Metro Inner Development Assessment Panel Agenda

- 3.1 Lots 130 – 131 (No.321) Guildford Road, Bayswater – Proposed Service Station, Car Wash and drive thru coffee (fast food)

Refuse DAP Application reference DAP/23/02575 and accompanying plans received in accordance with Clause 68 of Schedule 2 (Deemed Provisions) of the *Planning and Development (Local Planning Schemes) Regulations 2015*, and the provisions of the City of Bayswater Town Planning Scheme No. 24, for the following reasons:

Figure 20 – Swept path assessment 16.9 m Fuel Tanker with existing layout

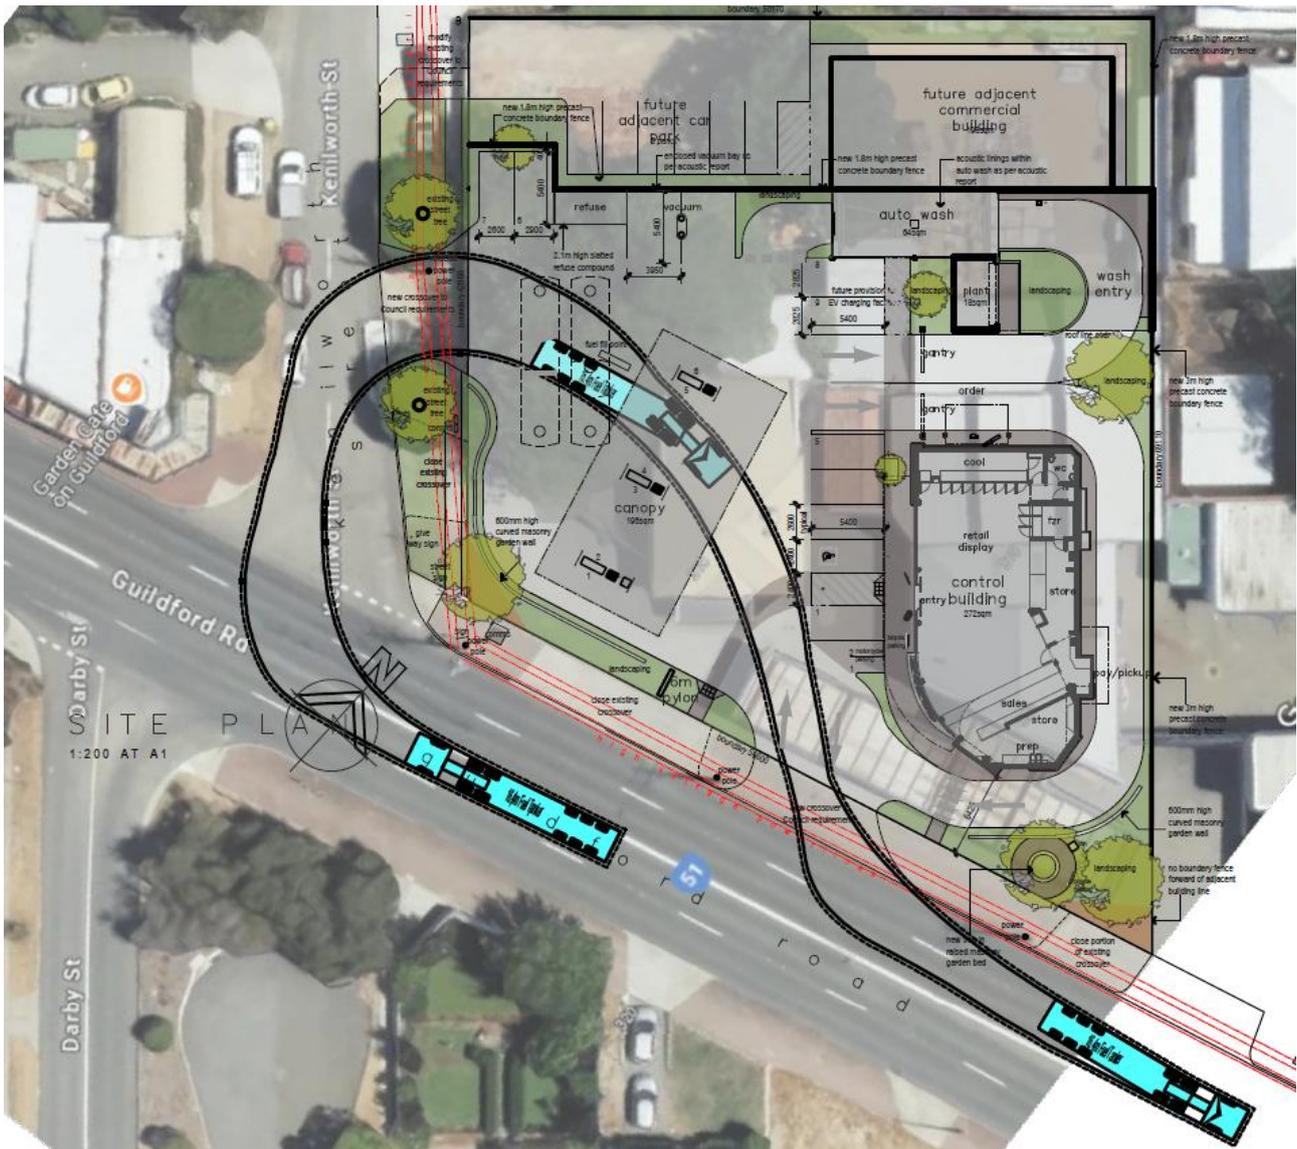
Figure 20 and Figure 21 shows fuel tanker access from the east, using the westbound lane to reach Kenilworth Street. The TIA's fuel tanker tracking is based on a 16.9m vehicle, with no justification for using a smaller tanker and no vehicle tracking is provided for a standard 19m tanker.

The City's engineers have advised that the TIA does not adequately address the access requirements for a standard 19-meter fuel tanker. This concern was also raised by MRWA during a meeting with the City, applicants, and MRWA in March 2025, where they discussed the proposal and future road planning. The City's engineers have further advised that the TIA does not include information on measures that will be put in place to ensure access to the site by compliant vehicles only. Additionally, it lacks details on operational controls to ensure safe and efficient fuel deliveries, particularly outside of peak traffic periods.

Figure 22 – Swept path assessment of B99 Design Cars with ‘PCI Right turn IN’ option and 16.9 m Fuel Tanker accessing site via proposed Kenilworth cul-de-sac as part of the Mian Roads WA widening project

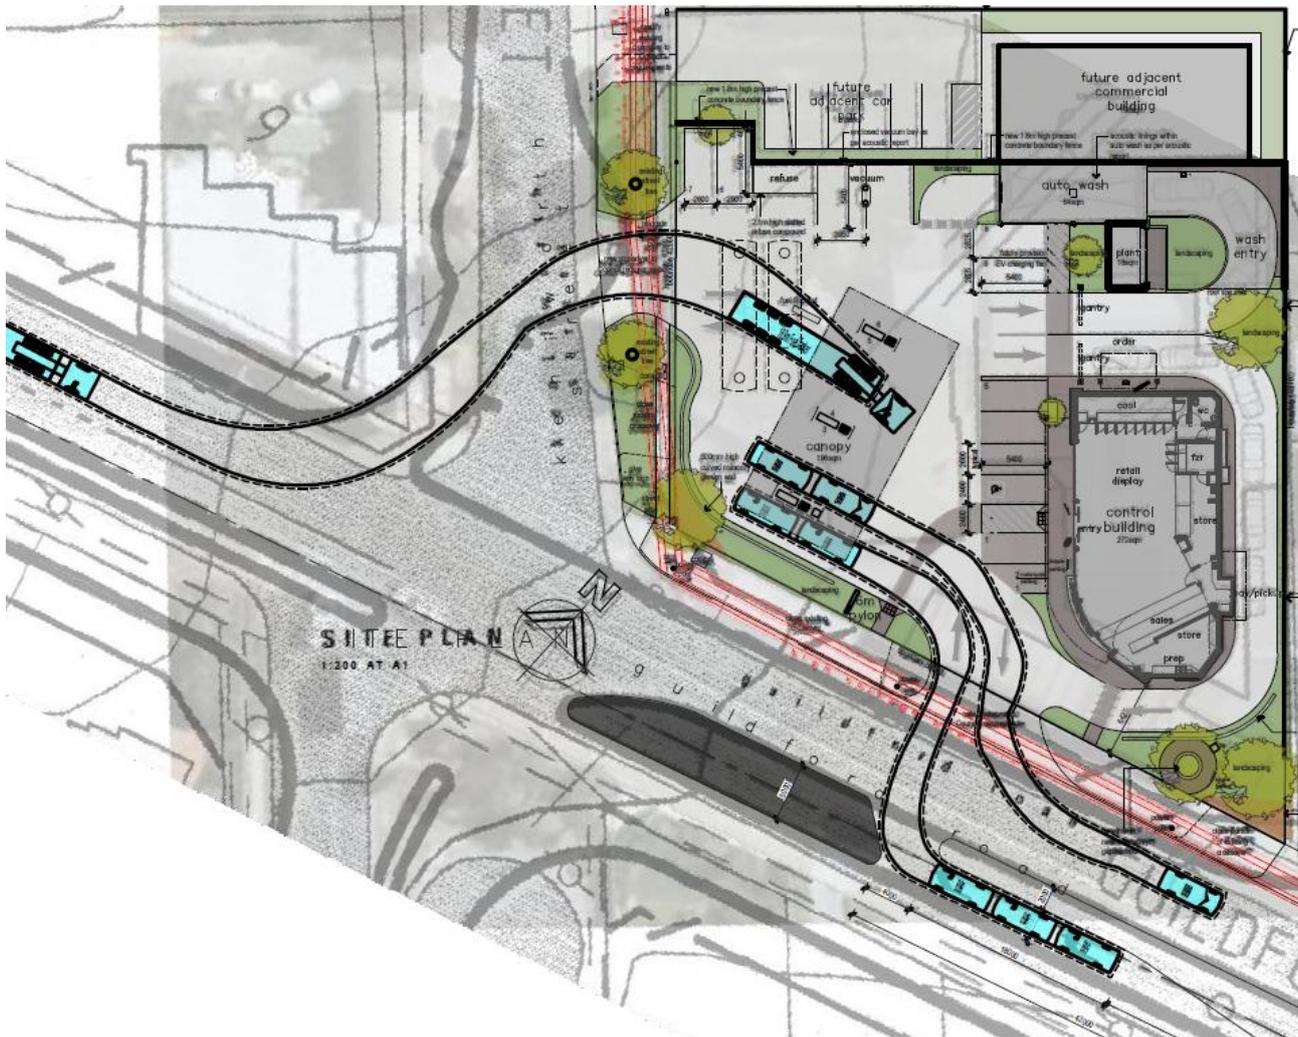
Figure 22 of the TIA shows how alternative fuel tanker access would be provided to the site from the west in accordance with future road planning for Guildford Road and indicates a 16.9m tanker encroaching on the footpath and awning at 317 Guildford Road, without demonstrating impacts for a 19m tanker.
